Federal Emergency Management Agency

IN REPLY REFER TO:
Case No.: 09-06-2899P
Community Name: City of Albuquerque, NM
Community No.: 350002
Effective Date of
This Revision: **March 25, 2010**

LETTER OF MAP REVISION DETERMINATION DOCUMENT

Boca Negra Arroyo Overflows - from approximately 500 feet northwest of the intersection of 81st NW and Amethyst Drive to approximately 400 feet west of that intersection

MIDDLE TRIBUTARY OF THE BOCA NEGRA ARROYO

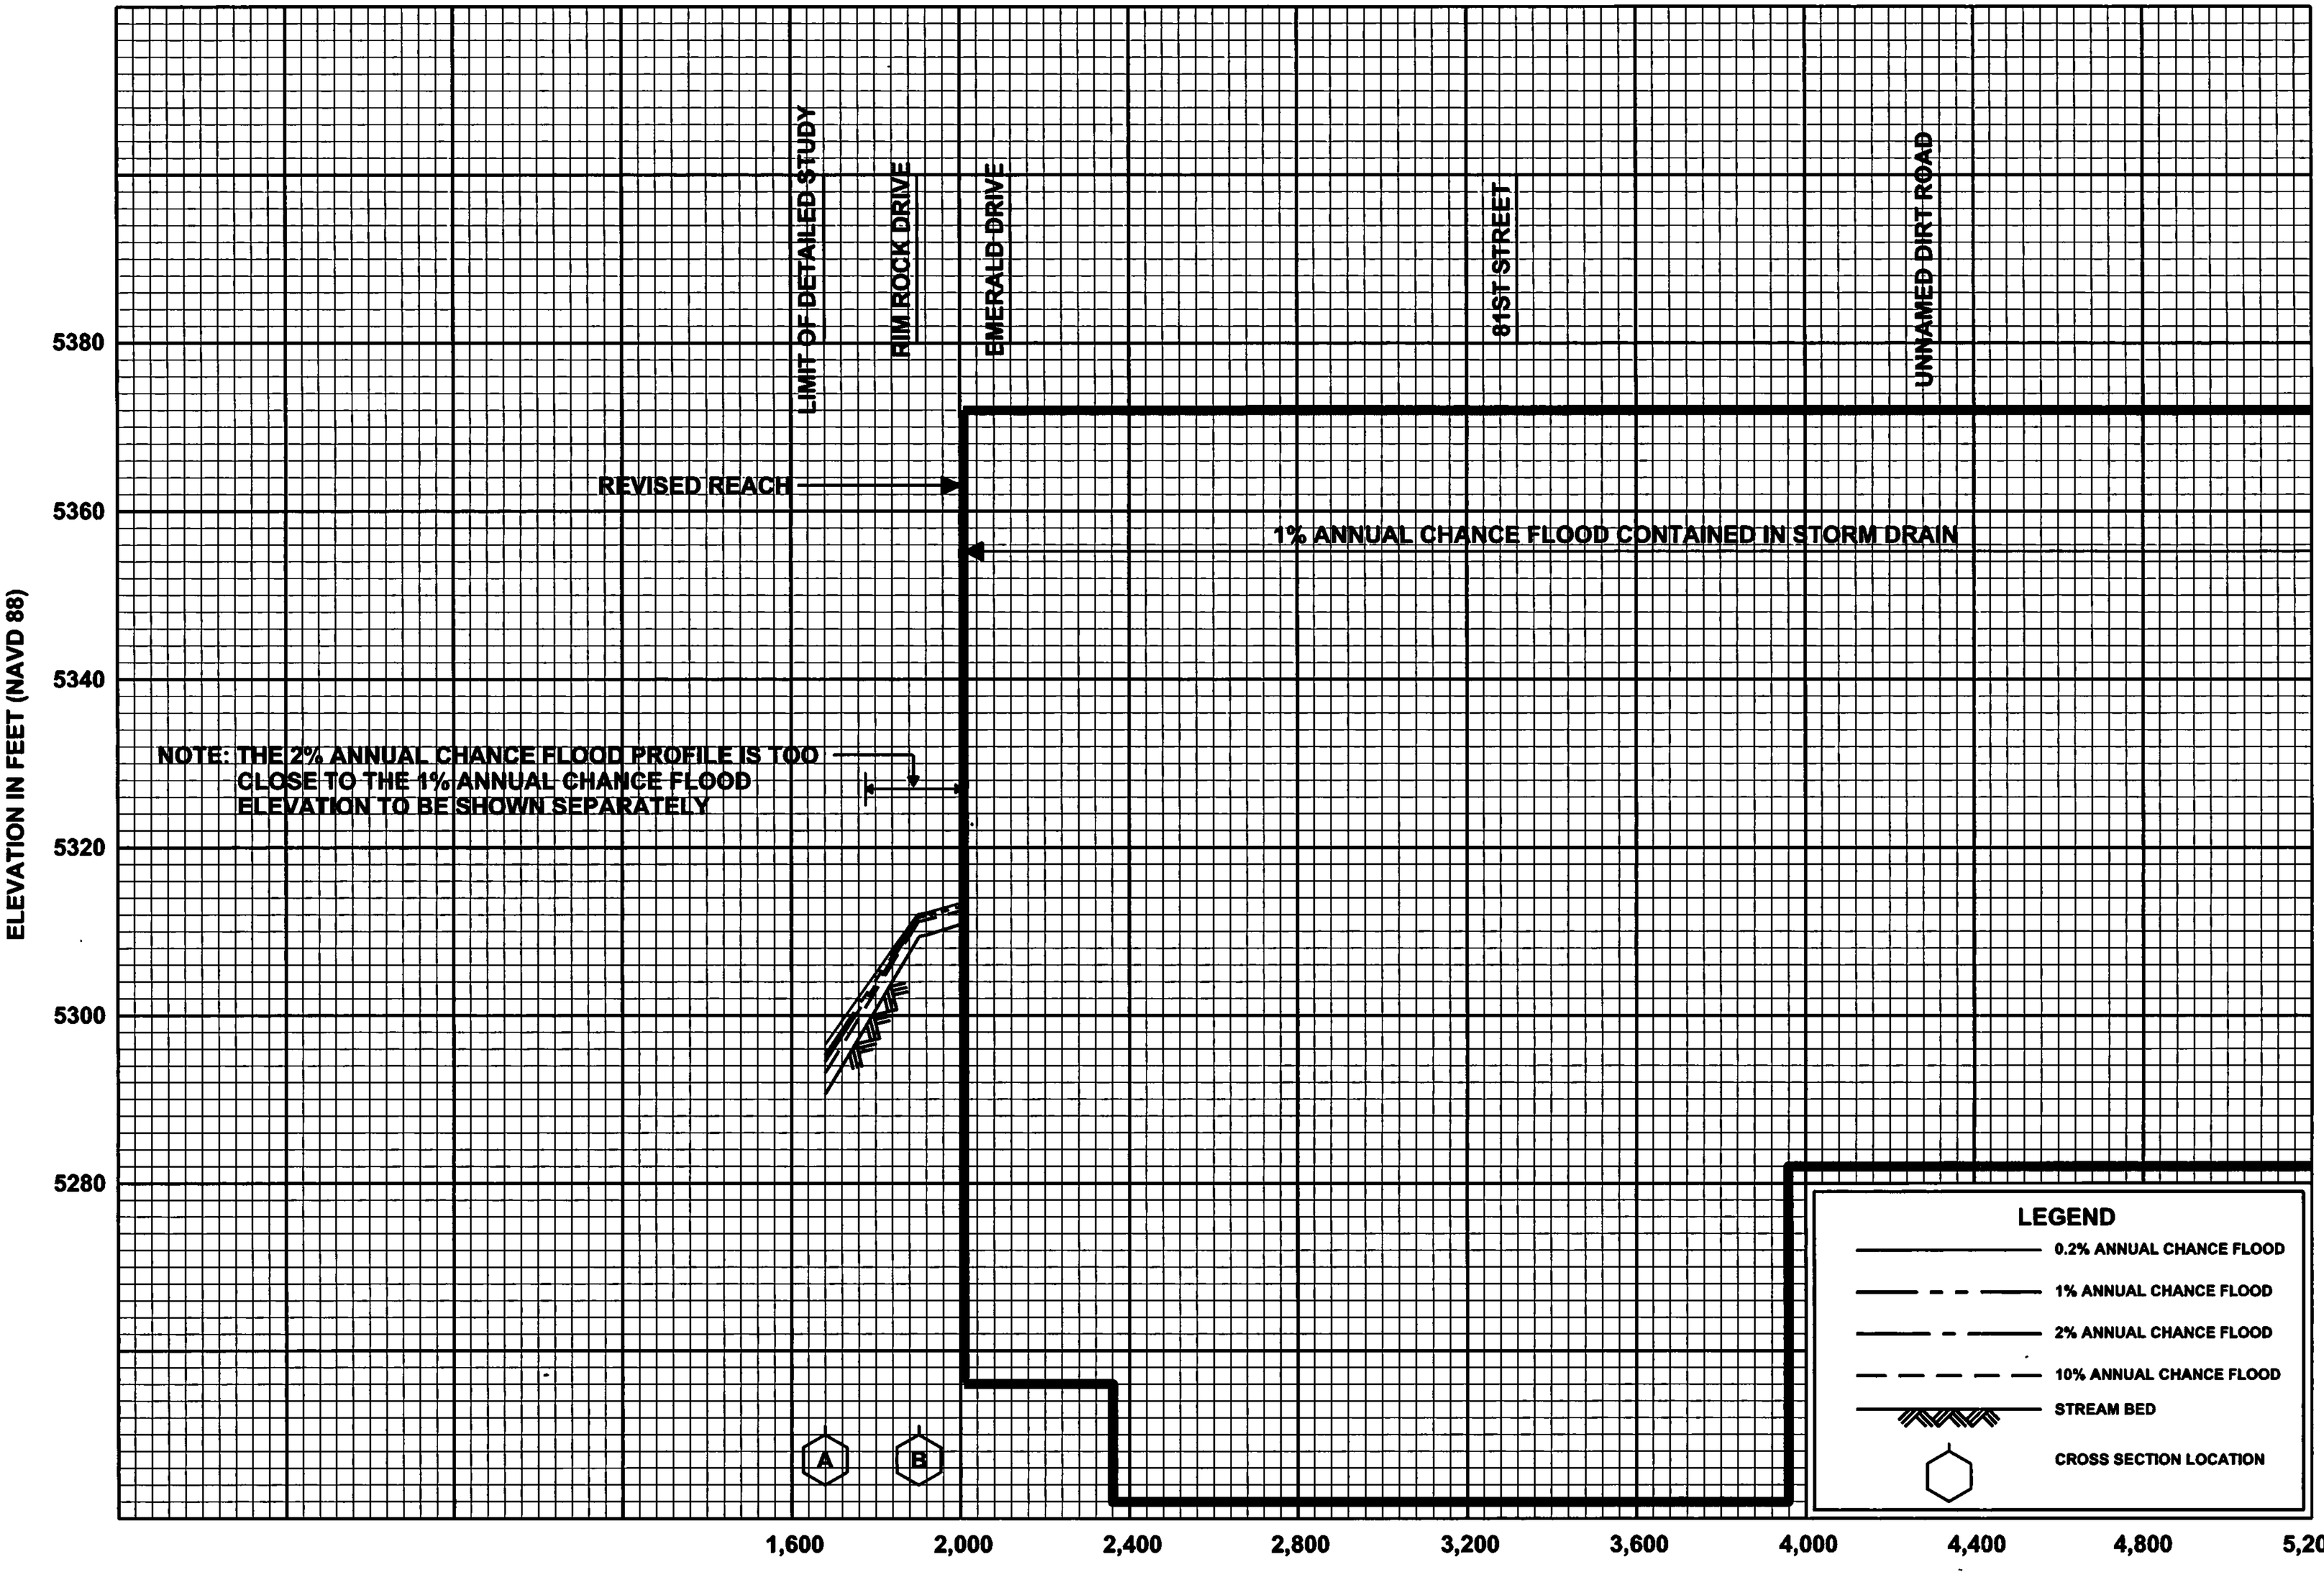
TABLE 13

FLOODWAY DATA

37P

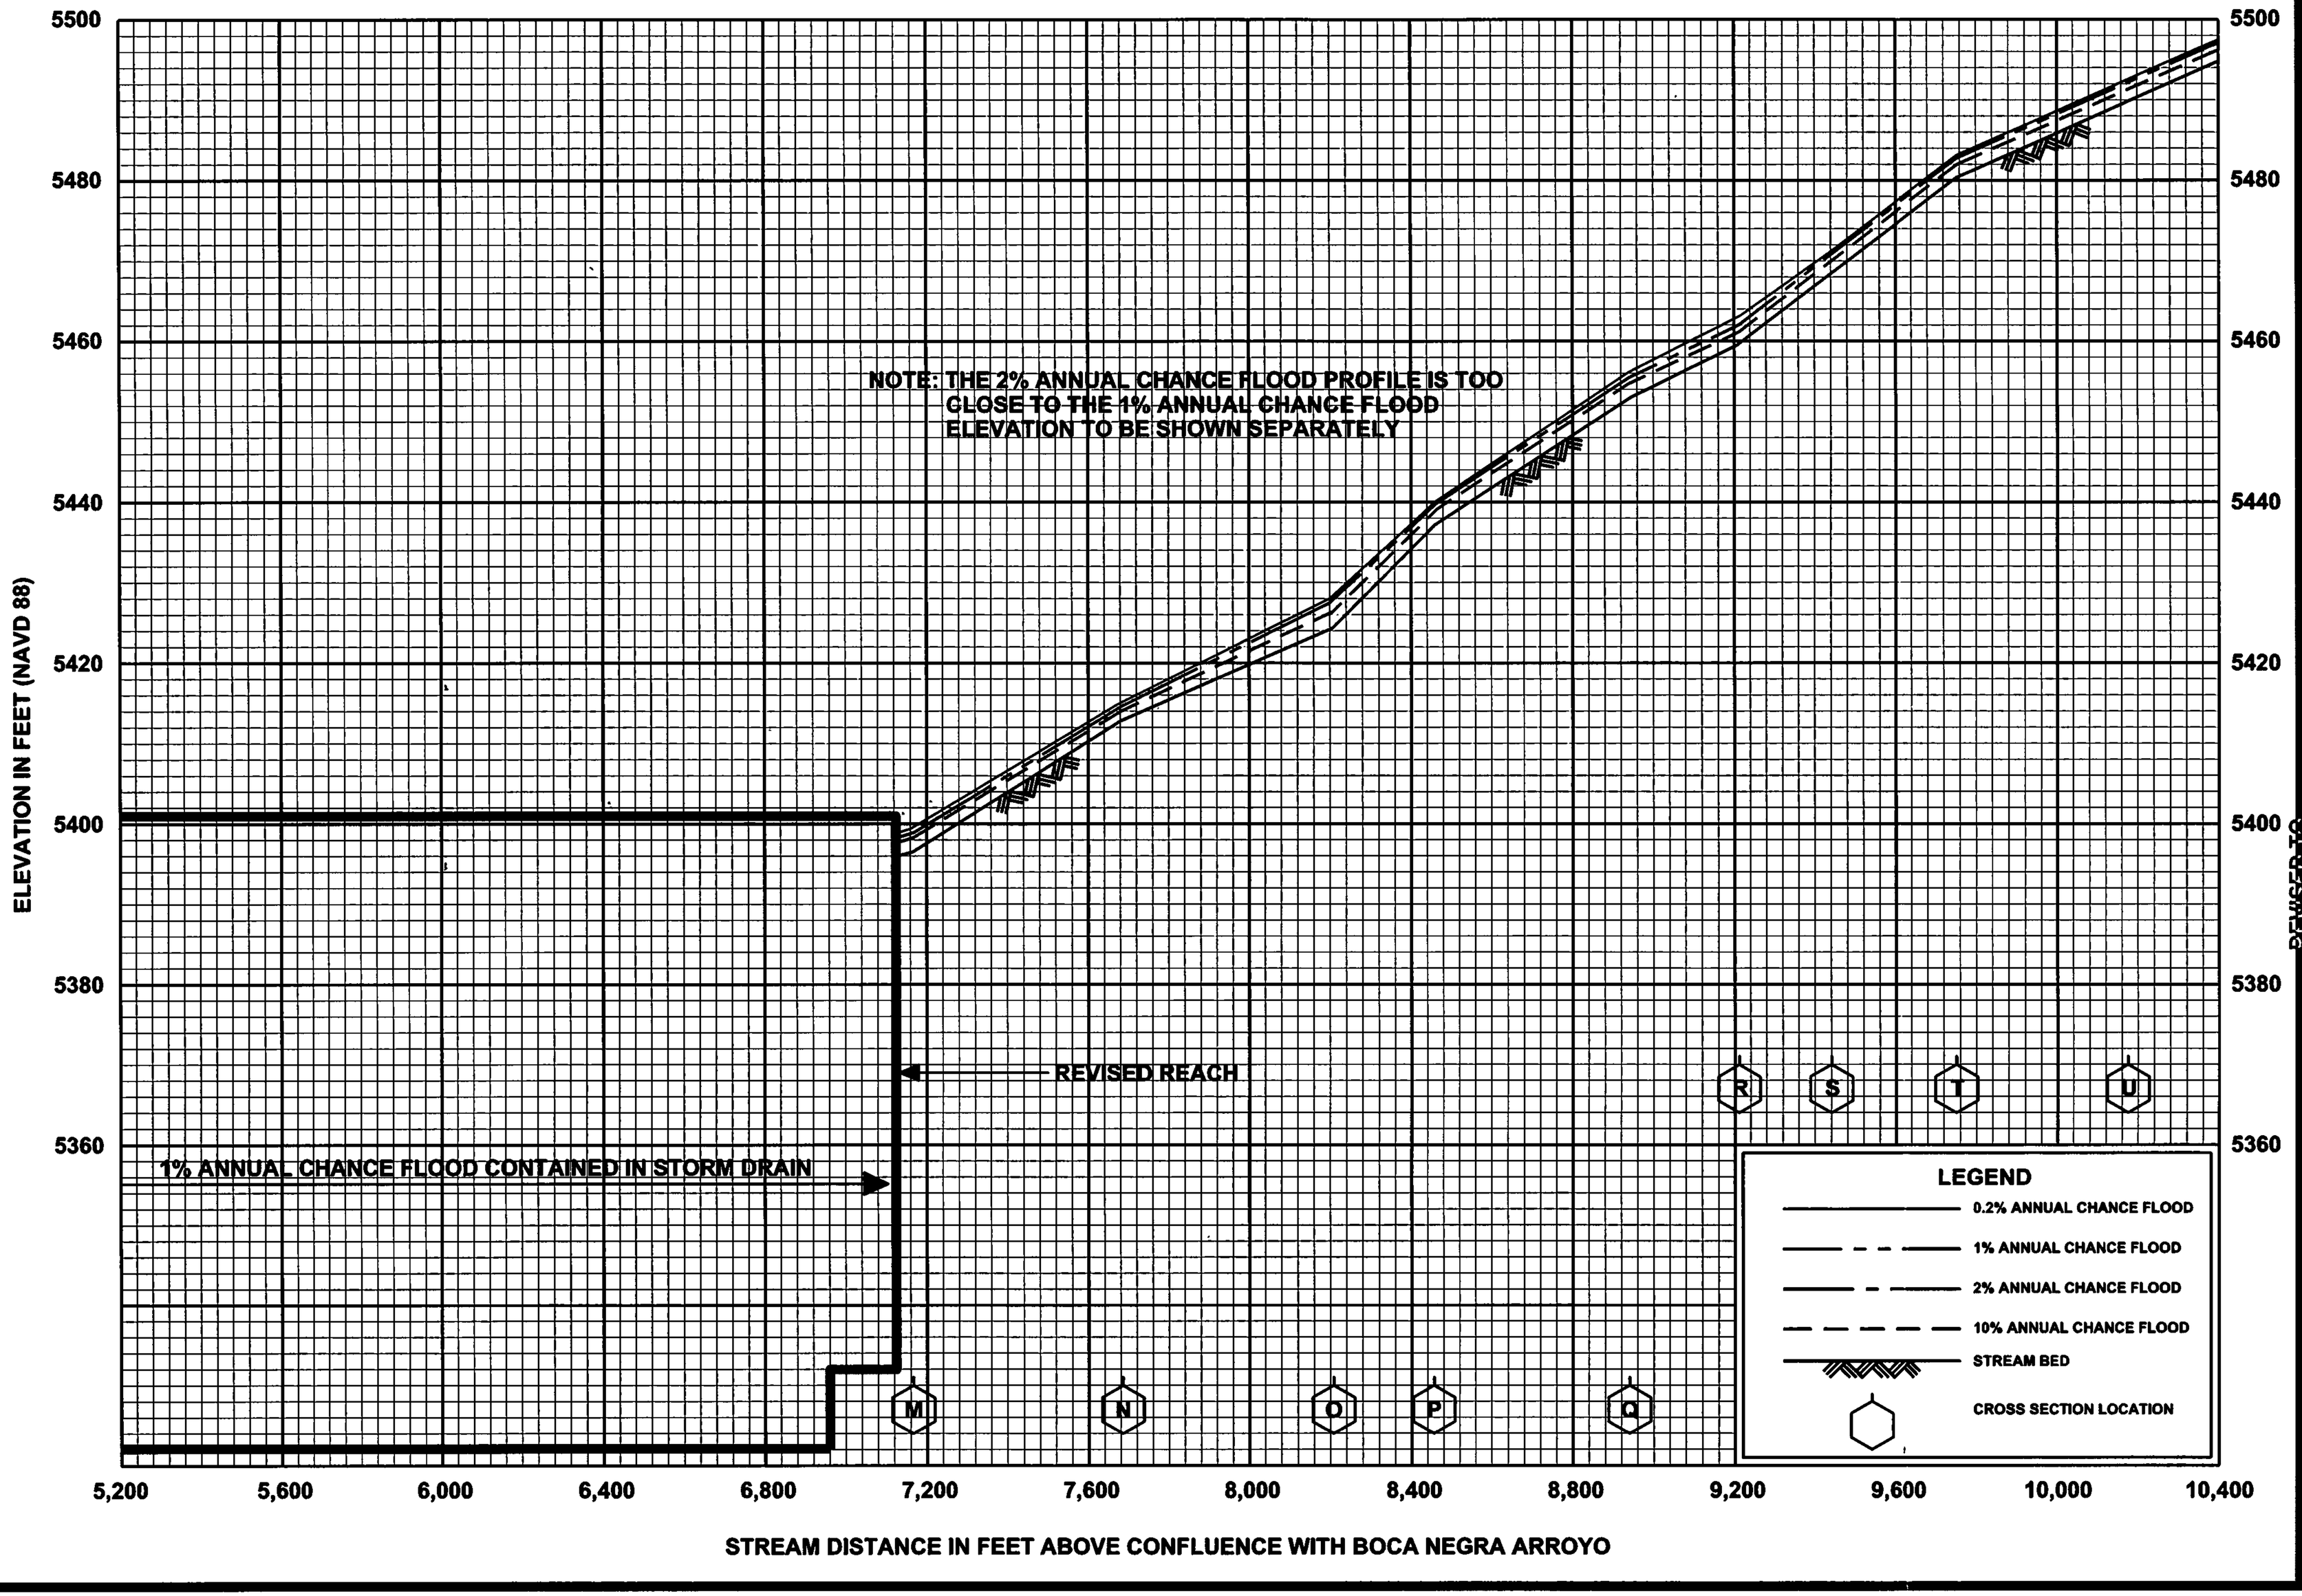
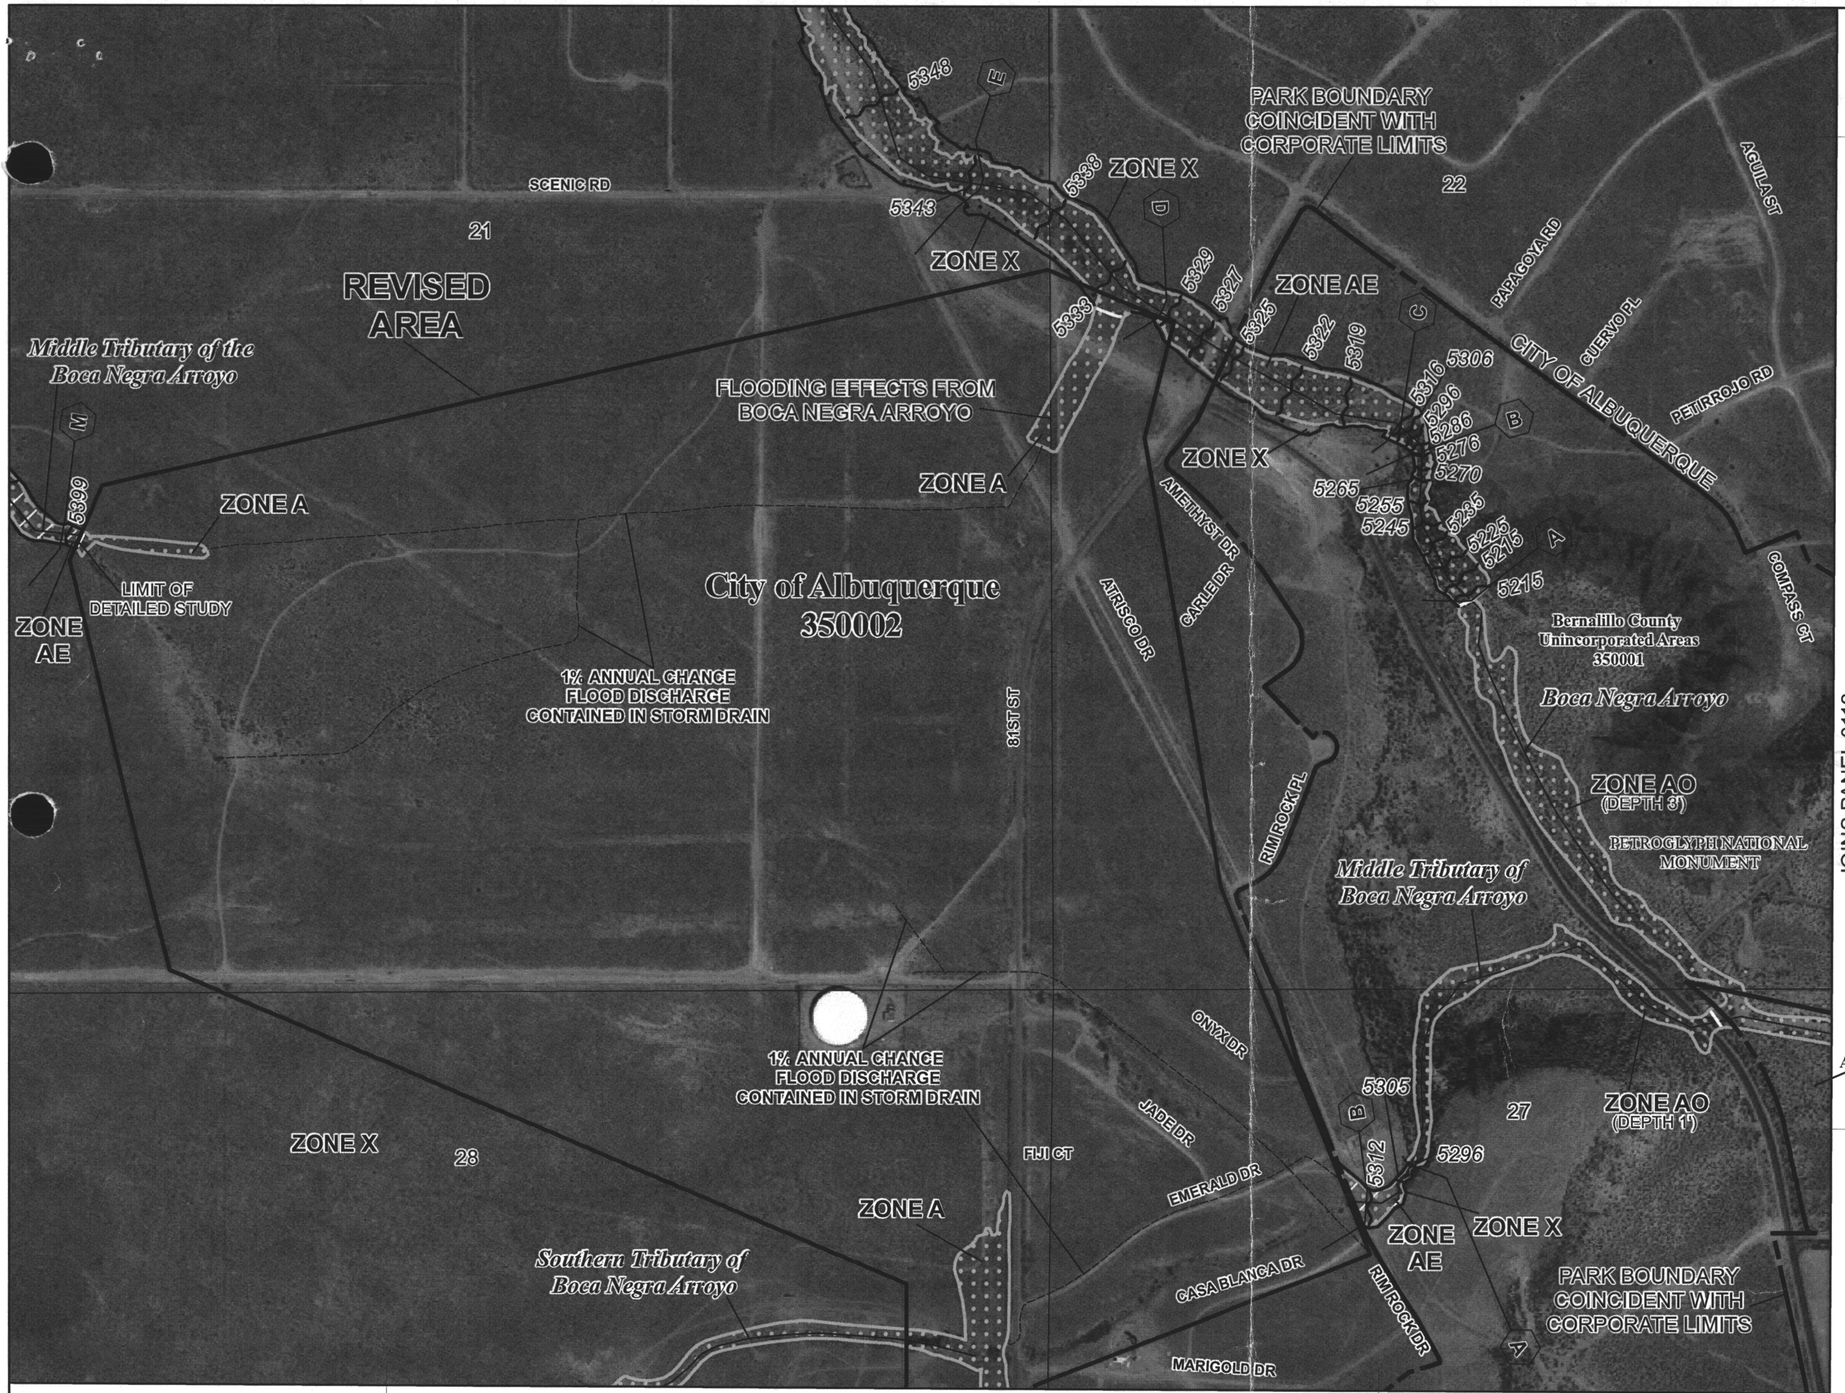
FLOOD PROFILES

REVISED TO REFLECT LOMR EFFECTIVE: March 25, 2010
